From: Maria Tomalova
Sent: Friday, February 18, 2022 3:58 PM
To: Peter Cleveland [REDACTED]
Subject: FW: Stakers Farm

From: Maria Tomalova
Sent: 16 February 2022 13:58
To: Martyn White <Martyn.White@arun.gov.uk>
Subject: Stakers Farm

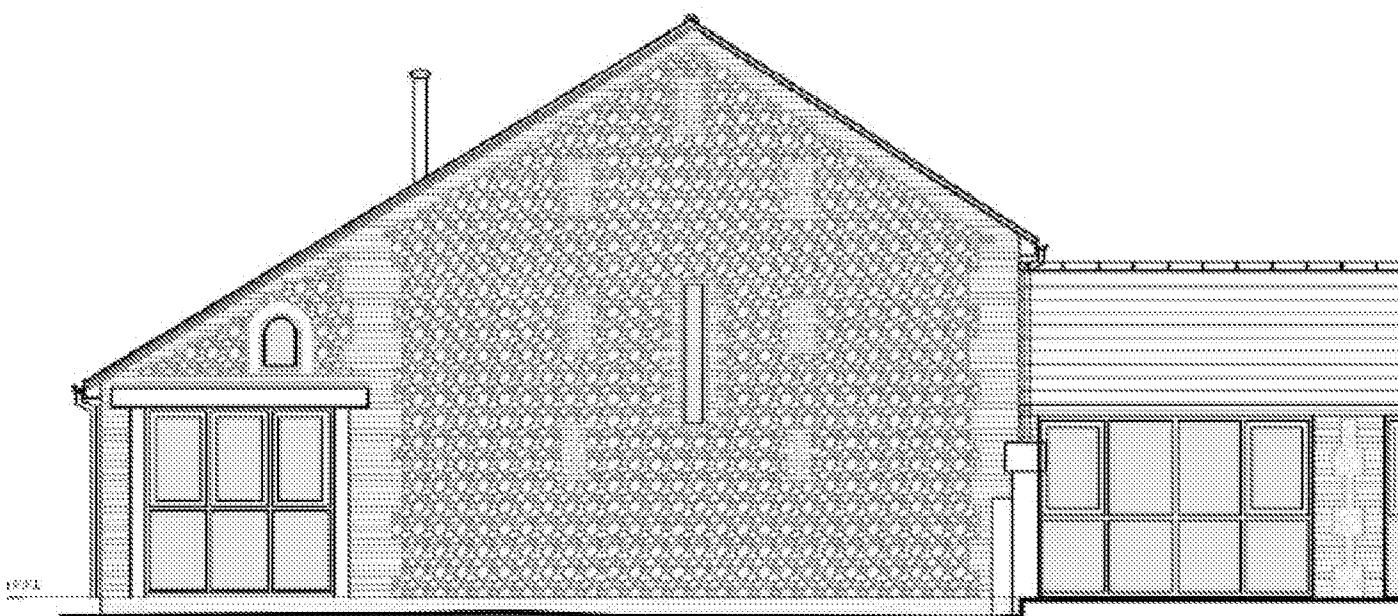
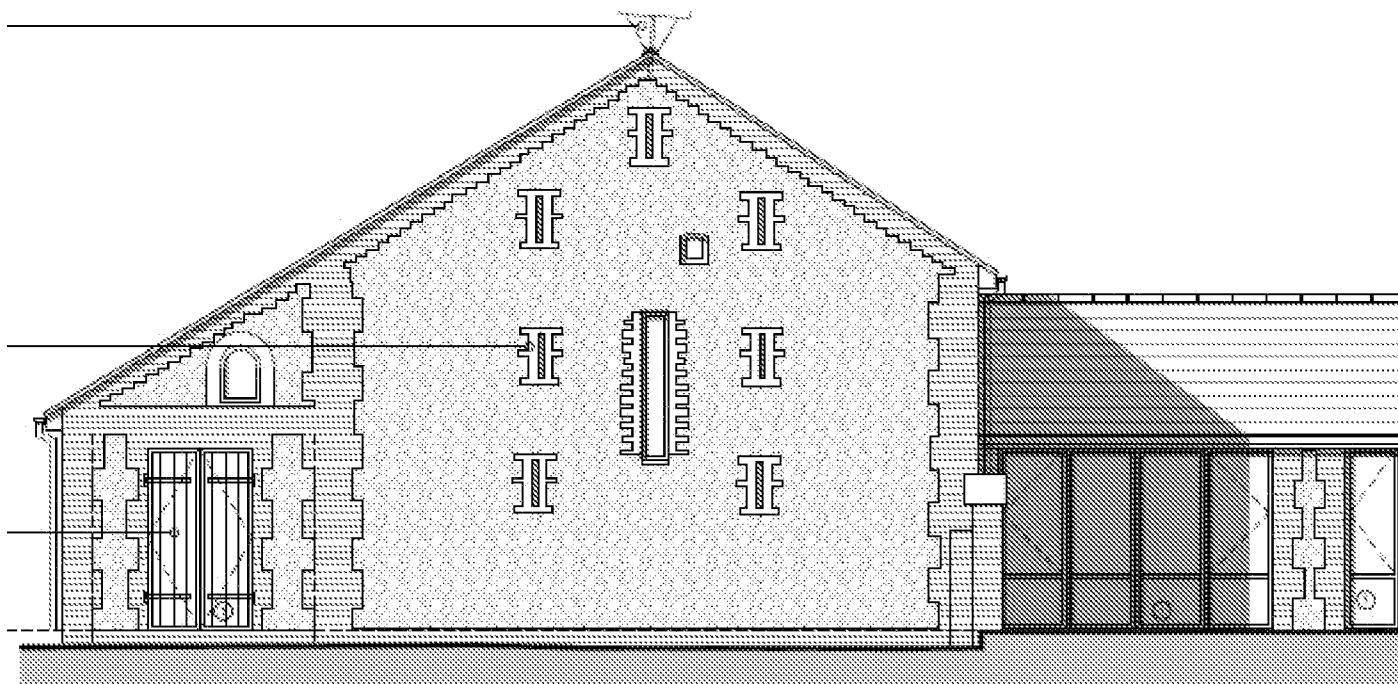
I do not understand, why they are showing bricks on this elevation to the right from the last opening; if you look at photo attached 1016 it shows flint.

Proposed North-West Elevation (A)

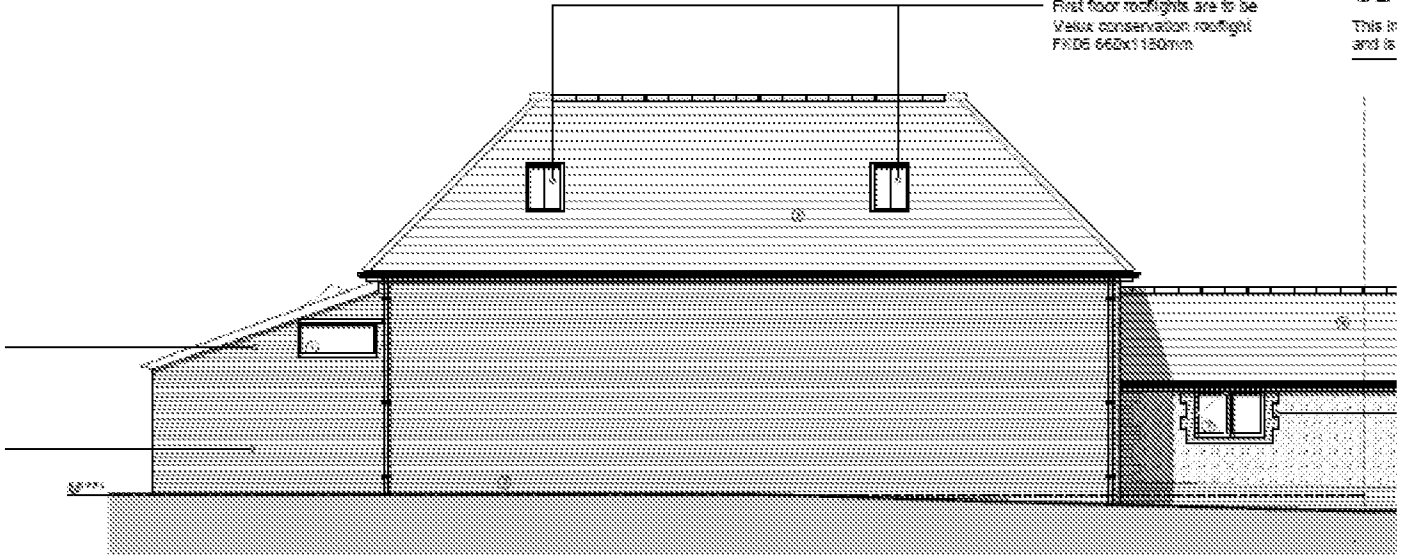
All the horizontal divisions should be back in the position where they were in approved plans and the same position should be maintain within all fenestration facing to the yard. The same apply for the largest opening. The replacement of the existing door (not original) as proposed is not acceptable and it would be helpful to discuss the replacement. There some other thing that should be clarified.
